ICHD - ENVIRONMENTAL HEALTH DIVISION

SEPTIC: IMPROVEMENT PERMIT / AUTHORIZATION TO CONSTRUCT / OPERATION PERMIT / EXISTING SYSTEM

Comments / Conditions: Redesignation of repair area for pool construction. Pool design shown on permit meets all required setbacks to installed system.

INITIAL SITE SKETCH

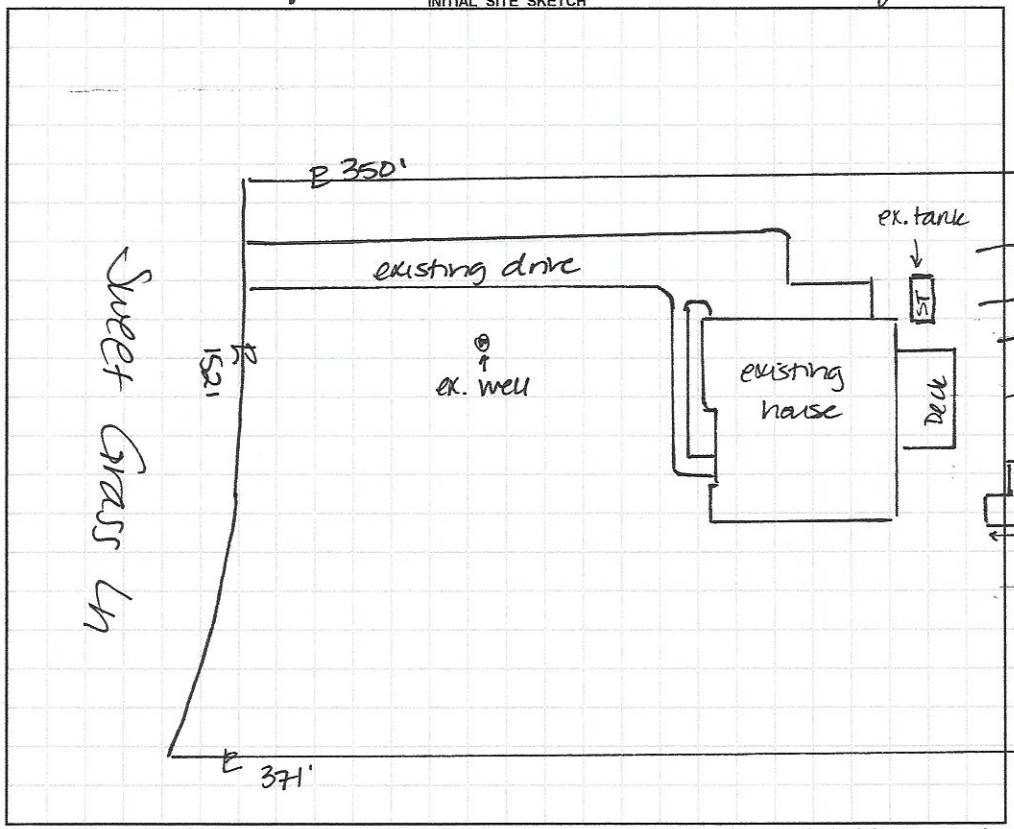
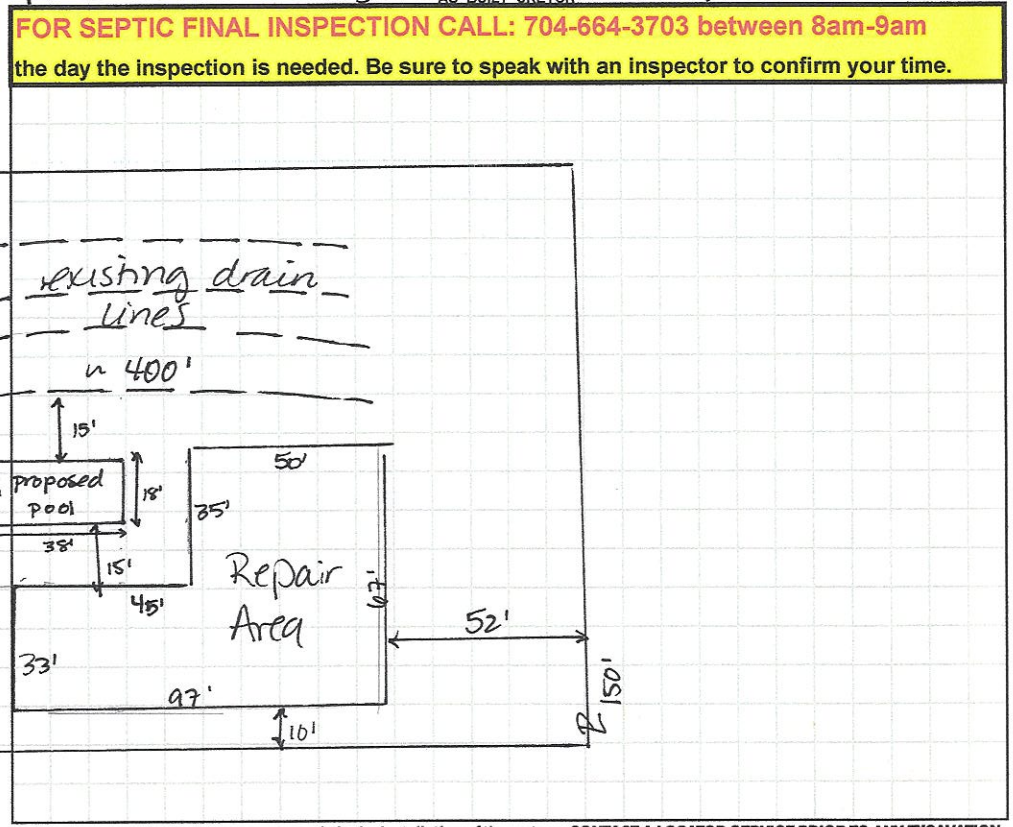
Recommend removing irrigation from all areas w/in 10' of existing system. Keep waters' edge of pool 15' off existing drainfield. Keep patio off drainlines.
